Re: Project Name: 1 Rosetta Street Condominiums, Georgetown, ON
Project Number: 20180721

Please find enclosed selected calculations and structural drawings for the proposed new crash wall located at the above-mentioned project. As required, only passenger trains at a max speed of 50mph operate along the line of interest. Refer also to the Appendix A for structural drawing sheets with details of the completed design. *We have updated Structural sketches to address AECOM comments. Please refer to notes on drawings. Background architectural ground floor is also updated.*

PROPOSED LOCATION OF
 EXPANSION/ISOLATION JOINT
 ON LEVELS UNDERGROUND LV.1
 GROUND AND 2ND FLOORS

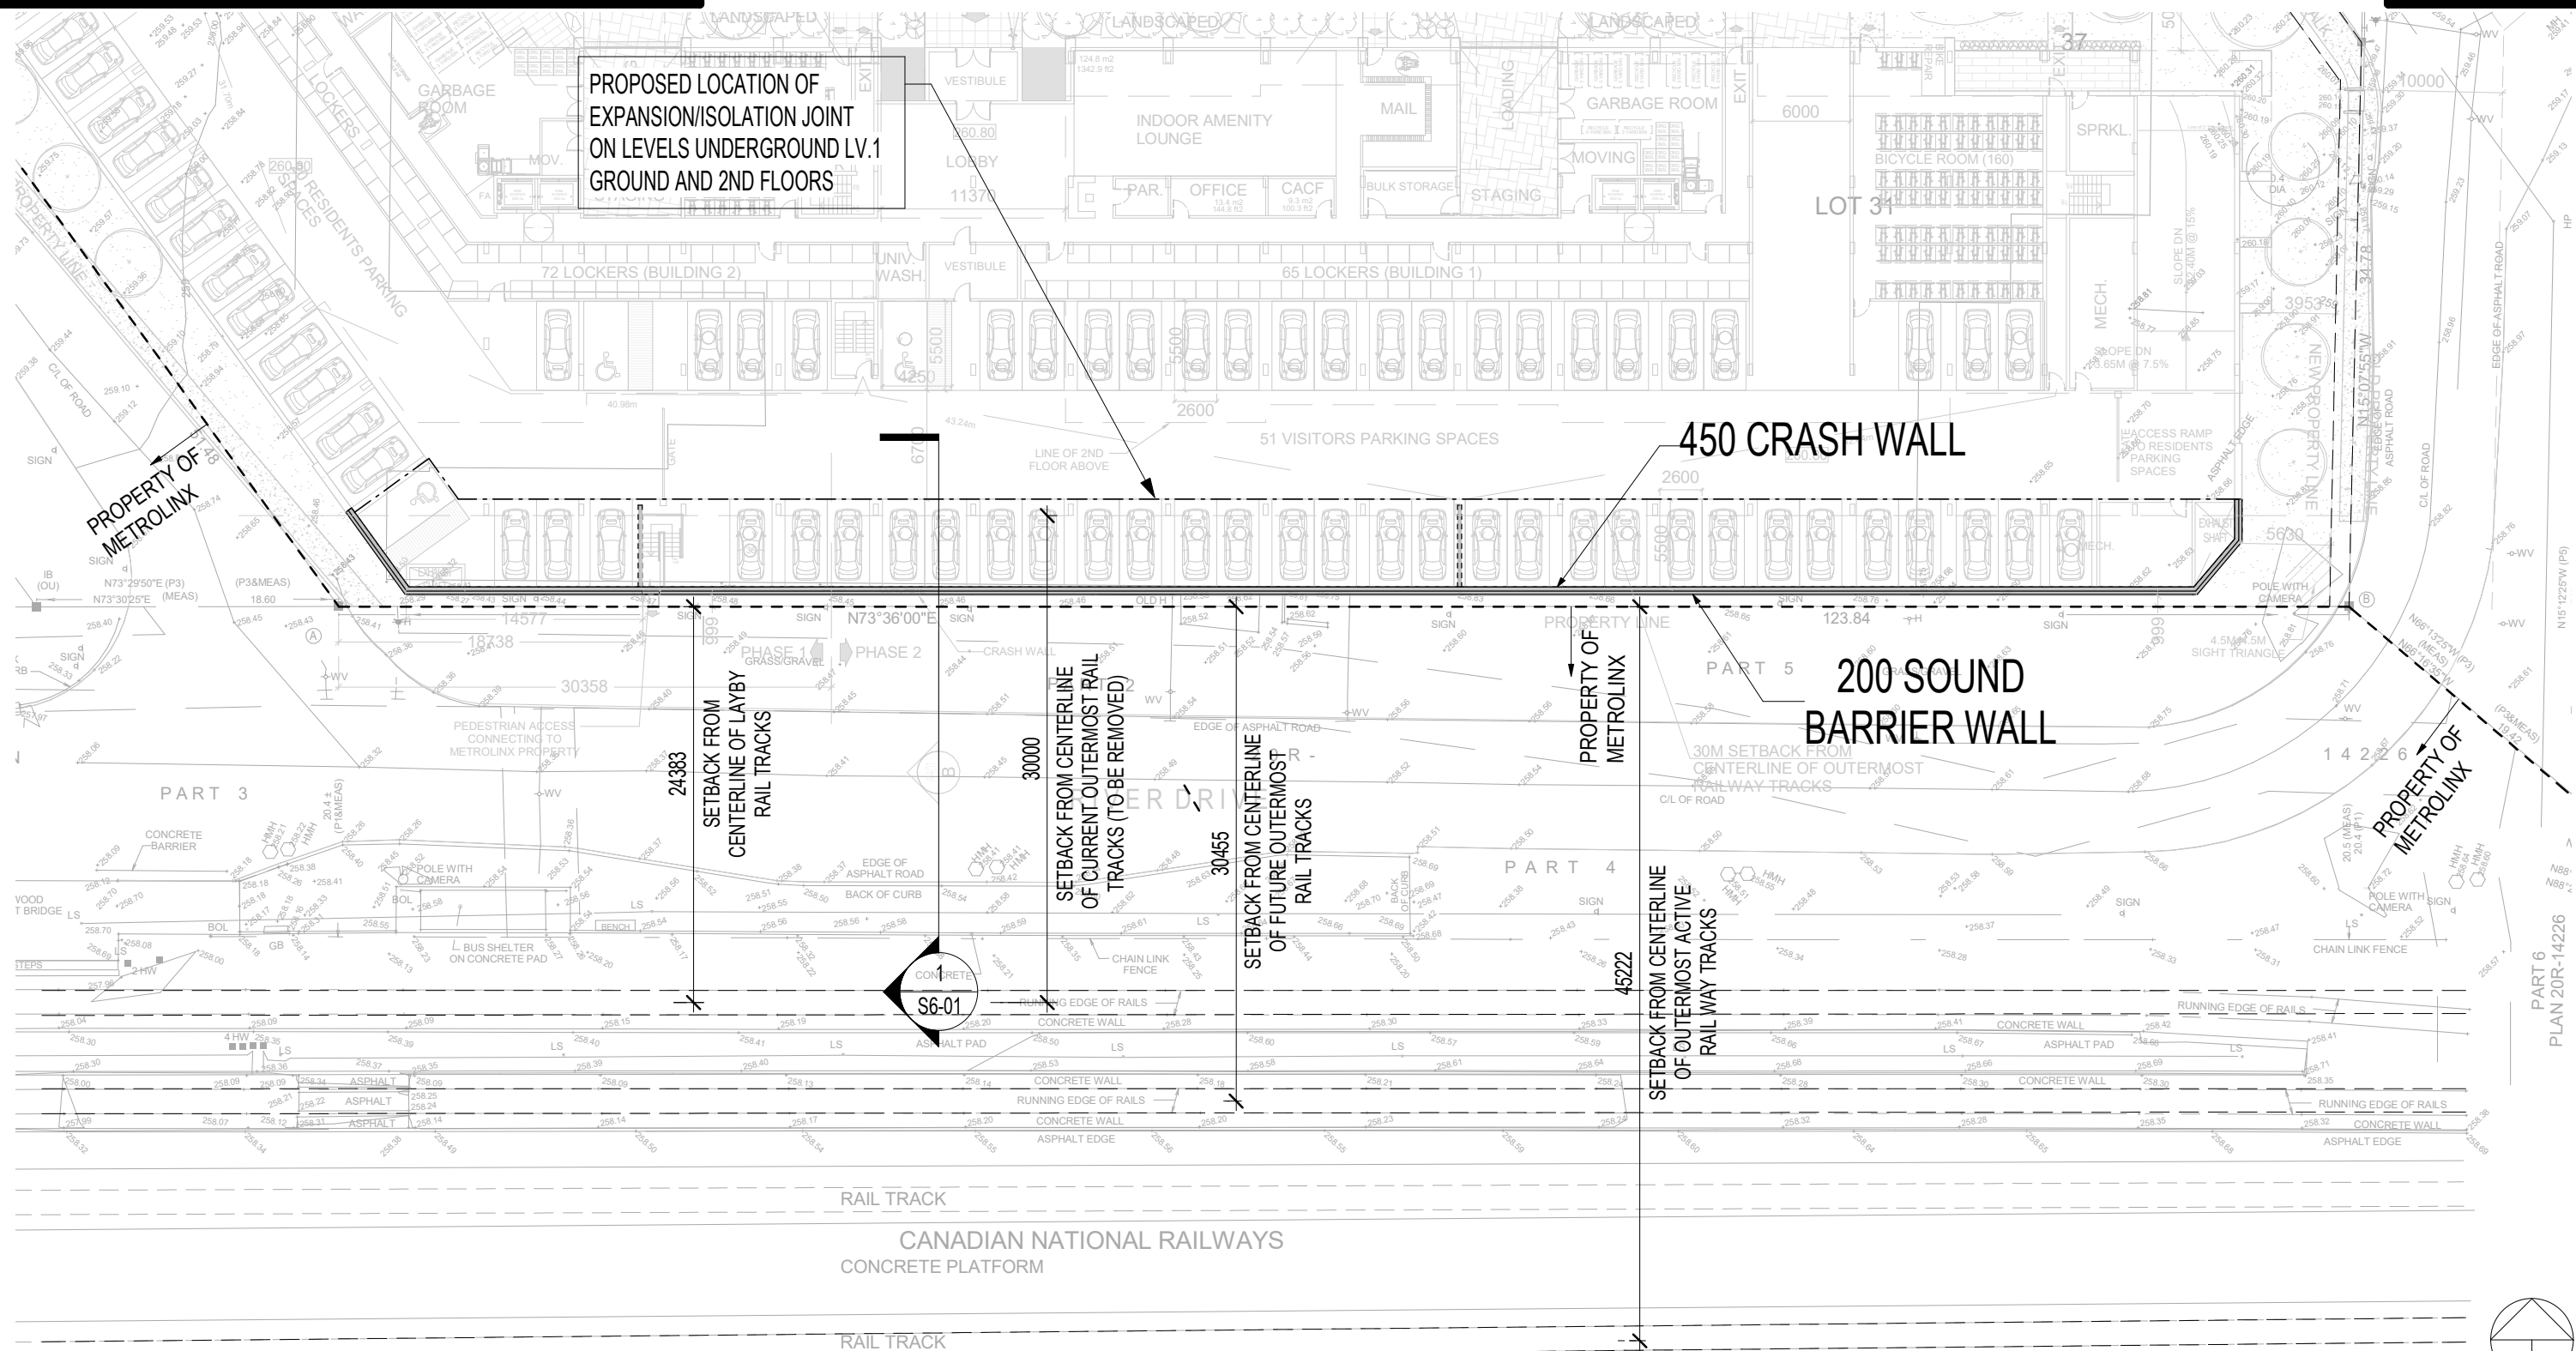
Podium levels connected to crash wall, are separated from residential tower by transfer beams and sliding bearings along expansion joint; these areas are allocated for parking spaces. Expansion joints and sliding bearings are introduced to mitigate noise and vibration as well as impact transmission to the residential spaces. See structural plan and section 1 on drawing S6-01.
